Request	-	Special Use Permit for a new Community Center
Location	-	2405 Stickney Avenue
Applicant	-	James Sherman New Covenant Church of the Living God 2405 Stickney Avenue Toledo, OH 43608
Design Professional	-	Anthony Coronado Midwest Church Design + Construction 634 Eckel Road Perrysburg, OH 43551

The staff recommends that the Toledo City Plan Commission recommend approval of SUP25-0021, a Special Use Permit for a new Community Center at 2405 Stickney Avenue, to the Toledo City Council, for the following three (3) reasons:

SPECIAL USE PERMIT
TOLEDO CITY PLAN COMMISSION
REF: SUP25-0021
DATE: August 14 2025
TIME: 2:00 P.M.

MINOR SITE PLAN: 2405 STICKNEY AVE

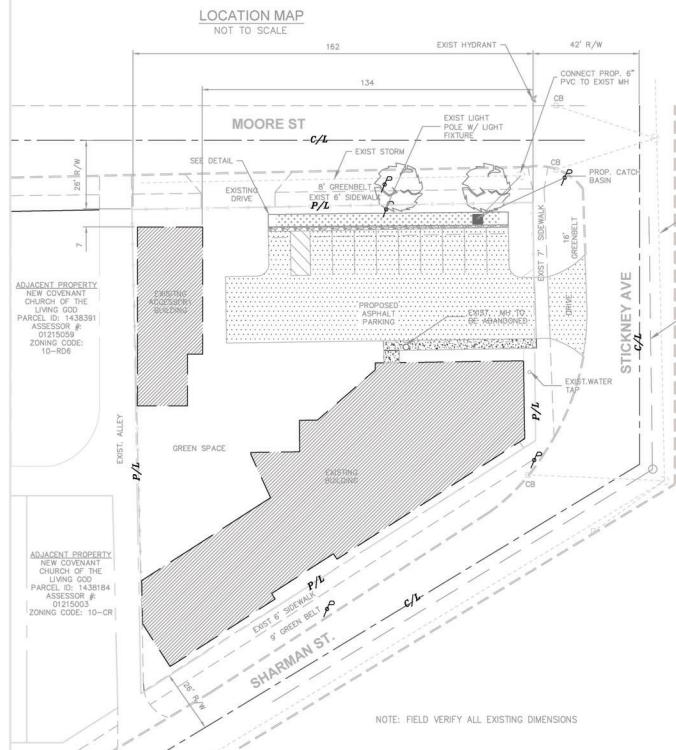
Off-street parking is not currently provided on this site. The applicant is proposing a small parking lot with ten (10) parking spaces at the corner of Stickney Avenue and Moore Street. The Plan Director has determined that this is an acceptable number of parking spaces per TMC§1107.0600 *Off-Street Parking Schedule "D"*. Due to the currently-proposed M-18-24, a Modification to TMC Chapter 11 – Zoning and Planning Code – Eliminating Parking Minimums, the applicant wishes to retain an option to not construct this proposed parking lot. If they wish to not construct the parking lot, they would be able to apply for a minor amendment to this special use permit to remove the parking portions of this approval.

TMC§1107.1700 requires one (1) of the proposed parking spaces to be van accessible in accordance with the Americans with Disabilities Act. This van-accessible space is shown; however, accessible parking must be located to provide the shortest path of travel to the building's accessible entrance. As such, the van-accessible space must be moved so that it is the closest parking space to the entrance. This requirement has been included as a condition of approval.

TMC§1107.1202 *Setbacks* requires the proposed parking lot to be set back at least fifteen feet (15') from Moore Street and Stickney Avenue. The parking lots are currently set back ten feet (10') from Moore St and Stickney Ave. This is discussed in more detail below.

TMC§1108.0202 *Frontage Greenbelt* requires a fifteen foot (15') wide frontage greenbelt along both Moore Street and Stickney Avenue. The site plan depicts ten foot (10') wide frontage greenbelts along Moore Street and Stickney Avenue. The proposed parking lot will need to be shifted five feet (5') south and five feet (5') west to accommodate the required fifteen foot (15') wide frontage greenbelt. This should not be difficult as there are grass areas with a minimum dimension of five feet (5') in both of these directions, although the proposed sidewalk on the southern end of the parking lot will become flush with the building. This has been included as a condition of approval.

TMC§1108.0202 *Frontage Greenbelt* also requires at least one (1) tree for every thirty feet (30') of frontage and a solid evergreen hedge planting within the Moore Street and Stickney Avenue frontage greenbelts. Sufficient evergreen screening has been provided; however, only one (1) new tree planting is proposed. An additional four (4) trees are required within the Moore Street greenbelt and two (2) trees are required within the Stickney Avenue greenbelt. The existing trees identified on the plan are within the right-of-way and – as stated in TMC§1108.0202(A) – may not be used towards frontage greenbelt requirements. The inclusion of these additional trees on a revised landscape plan has been included as a condition of approval.

Lastly for TMC§1108.0202 *Frontage Greenbelt*, stormwater treatment facilities may occupy up to fifty percent (50%) of the frontage greenbelt. The proposed stormwater treatment swale appears to occupy more than fifty percent (50%) of the Moore Street greenbelt. Staff believes the required increase in greenbelt width will bring the stormwater treatment swale's occupation of the greenbelt below fifty percent (50%). Even so, the assurance that the stormwater treatment swale occupies no more than fifty percent (50%) of the greenbelt has been included as a condition of approval.

TMC§1108.0204 *Parking Lot Landscaping* requires two (2) canopy trees and six (6) shrubs for every ten (10) parking spaces within parking lots. As such, two (2) canopy trees and six (6) shrubs are required for the parking lot's interior landscaping. The depiction of these additional trees on a revised landscape plan has been included as a condition of approval.

18. Bicycle parking spaces shall meet the standards of TMC§1107.0902. **Pole/rack details shall be submitted to the Planning Director.**
19. Pursuant to TMC§§ 1107.1202 & 1108.0202 the proposed parking area shall be shifted to ensure a fifteen-foot (15') setback and frontage greenbelt on both Moore Street and Stickney Avenue. **Not acceptable as depicted. A revised site and landscape plan shall be submitted to the Plan Director depicting the required parking lot setback.**

20. Pursuant to TMC§1108.0202 the frontage greenbelts along Moore Street and Stickney Avenue require at least one (1) tree for every thirty feet (30') of frontage. **Not acceptable as depicted. A revised landscape plan shall be submitted to the Plan Director depicting a minimum of four (4) trees within the Moore Street greenbelt and two (2) trees within the Stickney Avenue greenbelt.**

21. Pursuant to TMC§1108.0202 stormwater treatment facilities may occupy up to fifty percent (50%) of each frontage greenbelt. **Not acceptable as depicted. A revised landscape plan shall be submitted to the Plan Director depicting the stormwater treatment facilities less than fifty percent (50%) of each frontage greenbelt.**

22. Pursuant to TMC§1108.0204 two (2) canopy trees and six (6) shrubs are required within parking lots for every ten (10) parking spaces. **Not acceptable as depicted. A revised landscaping plan shall be submitted to the Plan Director depicting a minimum of two (2) trees and six (6) shrubs within or immediately adjacent to the proposed parking lot.**

ELEVATIONS

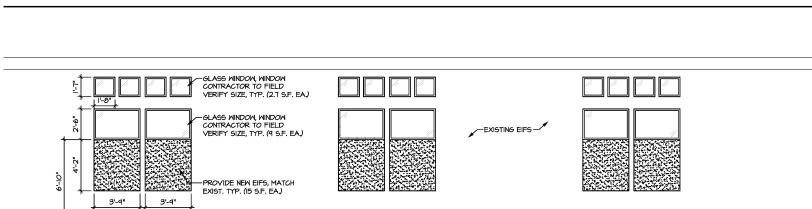
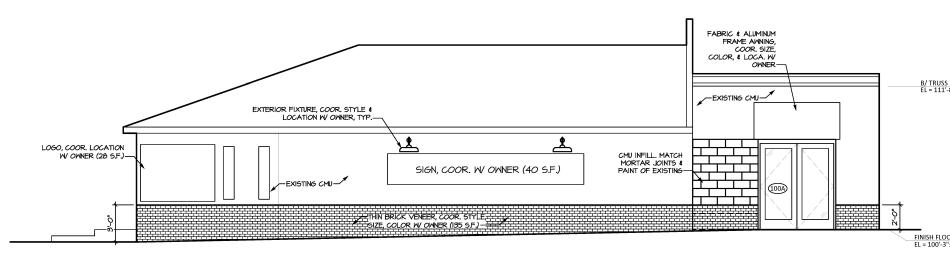
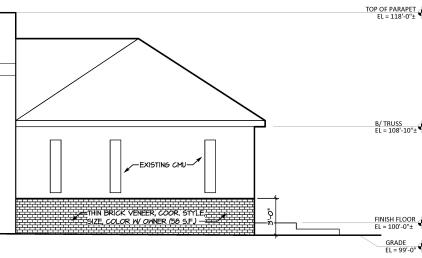
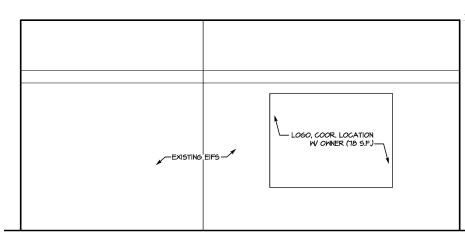
The applicant has proposed some changes to the existing building's façade. The building currently consists of primarily Exterior Insulation Finish System (EIFS) materials on façades visible from Sherman Street and Concrete Masonry Units (CMU) on other façades. Boarded-up openings for windows are on most façades. Proposed changes include a two to three foot (2'-3') tall thin-brick veneer along the foundation of façades consisting of CMU and filling in some of the window openings with like material for that façade – whether EIFS or CMU. Window openings which are not filled with EIFS or CMU are proposed to be fitted with new windows.

TMC§1109.0502 requires commercial/institutional structures to consist of at least eighty percent (80%) predominant materials and no more than twenty percent (20%) accent materials. The section defines EIFS and Architectural CMU as accent materials. Windows and brick are defined as predominant materials. Unfinished CMU is prohibited by the design standards. As this is an existing non-conforming building full compliance with the design standards of TMC§1109.0500 is not necessary; however, proposed work cannot increase the extent of the nonconformity. As such, no portion of any façade which was not previously an accent material may be filled with an accent material. This includes the filling of window holes and garage doors. Ideally all window holes would be fitted with windows; however, the applicant may choose to fill them in with any of the predominant materials listed in TMC§1109.0502. This has been included as a condition of approval.

TMC§1109.0502 requires commercial/institutional structures to have a predominant subtle, neutral, or earth-tone color, with accent colors permitted to take up only 20% of each façade. No colors are noted on the proposed elevation drawings; however, adherence to this requirement has been included as a condition of approval.

The applicant has shown three (3) signs/logos on the proposed elevations. It appears that the proposed signage may meet the requirements of TMC Chapter 1113 *Signs*; however, a review of the proposed signage was not conducted as a part of this Special Use Permit review. All signage must obtain a sign permit prior to installation. This has been listed as a condition of approval.

26. Proposed modifications to the existing structure may not increase its level of nonconformity with TMC§1109.0500. **Not acceptable as depicted. Revised elevations shall be submitted to the Plan Director depicting no portion of any façade which was not previously an accent material being replaced/filled with an accent material. Accent material is defined in TMC§1109.0500.**

27. Proposed color changes to the existing structure shall remain in compliance with the building color requirements of TMC§1109.0500.
28. Applicant shall obtain appropriate permits for any proposed signage, subject to TMC§1113 *Signs*.
